IMPORTANT SAFETY RECALL 18V-008 (SN663)

Safety Notice

Models Affected: XTPro56 & XTPro 60 Aerials

SUBJECT: Single Stick Control Adjustment

Issue:

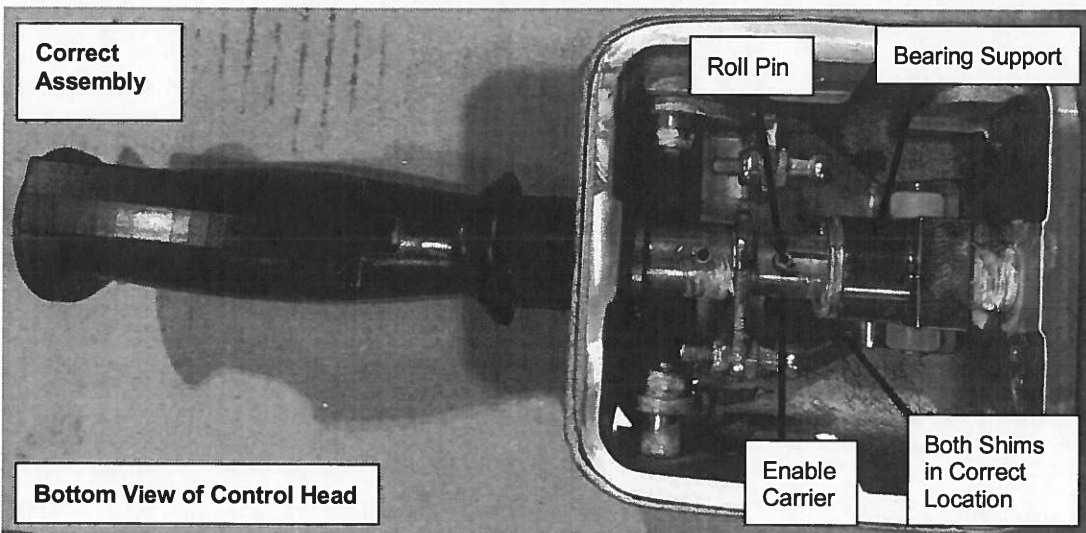
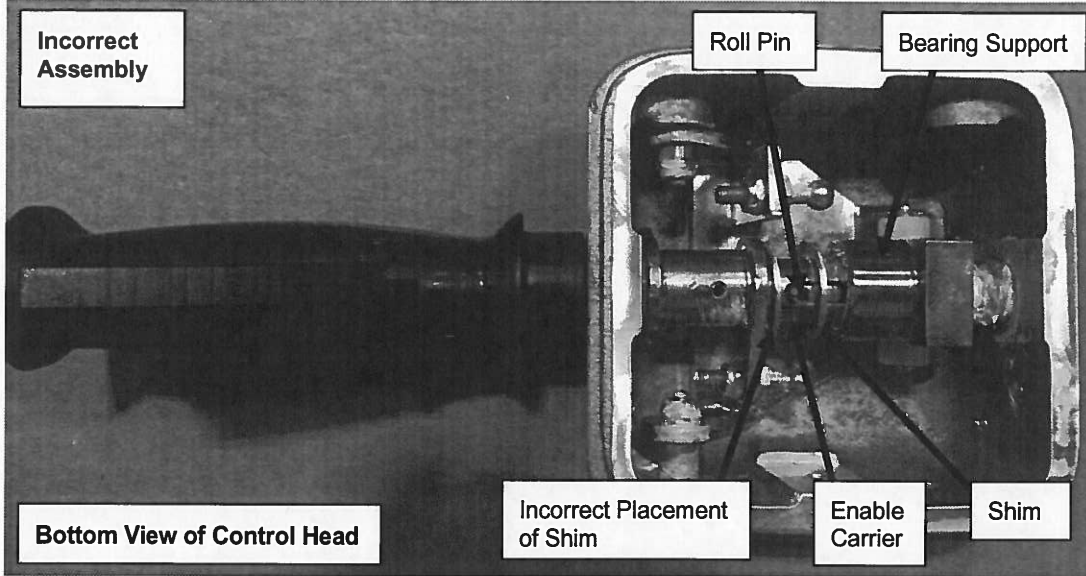
Some XTPro units may have upper control single stick enable trigger adjusted or assembled incorrectly. If the enable trigger is not adjusted correctly, the boom could function without depressing the enable trigger. **Inadvertent boom movement may occur if the single stick is operated without depressing the enable trigger.**

- a. Remove the plastic cap and lower the boot over the single stick mechanism.
 - b. Inspect the position of the two shims on the enable carrier.
 - c. If only one shim is between the roll pin and bearing support, the single stick is assembled incorrectly. Contact your local TEREX dealer to arrange repair. The control head must be assembled properly to provide allowance for wear to attain rated boom speeds.

- d. If both shims are between the roll pin and bearing support, the single stick is assembled properly. No further action is required for this bulletin. Continue to perform regular inspections and maintenance as stated in the manuals.
